**Armstrong House
3 Bassett Avenue
Southampton
SO16 7DP**

Date: 10th May 2023
Reference: R9784-2 Rev 1

Re: Willow Way Sydenham – Noise Addendum

FIGURE 1 – FOURTH FLOOR PLAN SHOWING EXTERNAL AMENITY

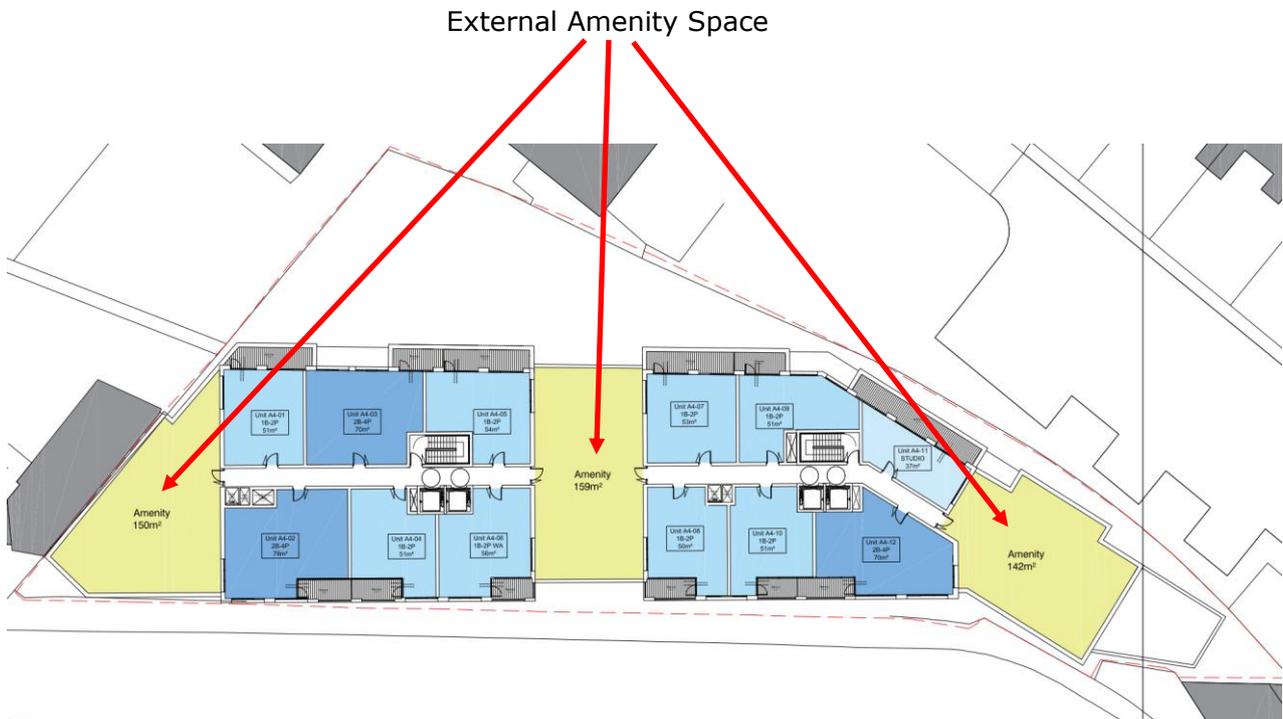
"I note the acoustic submission prepared by 24 Acoustics ref. R9784-1 Rev 1 which reports at Section 5.8:

'External communal amenity spaces are proposed on the east side of the new building at ground floor level and in three roof terrace areas on the fourth floor. The noise measurement results indicate that external noise levels within all the communal amenity spaces would be comfortably below 55 dB LAeq, 16 hour and therefore acceptable.'

"However, from the data presented at Table 1 – Measured Noise Levels at Location 1 – Overlooking High Street the representative daytime (LAeq16hr) is reported at 59 dB i.e. in excess of the value above. Further, with the Planning Statement dated 20th December 2022 states:

'The amenity space provided for the residential element of the Proposed Development comprises private balconies for each unit plus communal open space located on the 4th floor.'

As such is it possible to seek clarification from the Applicant's Acoustic Consultant as to why it appears the data presented in Table 1 has been 'screened out' and reliance placed upon the data presented in Table 2 or provide details of any additional mitigation measures proposed."

- 2.3 The proposed external spaces for residential amenity will be on the fourth floor roof terraces, as shown in Figure 1. The ground floor amenity space at the rear of the building will be a visual amenity area used as a breakout space by the staff of the commercial units only.

- 2.4 Table 1 of 24 Acoustics' report presents the measured noise levels at the western boundary of the site facing Willow Way, with 59 dB LAeq, 16 hour as the representative daytime noise level at this location. In order to determine external noise levels within the proposed fourth floor external amenity spaces, the measured noise levels at location 1 were corrected for losses due to distance and acoustic screening from the building itself.

- 2.5 With corrections for distance and screening as described, calculations confirmed that noise levels within the fourth floor external amenity spaces would be comfortably below 55 dB LAeq, 16 hour and therefore acceptable.
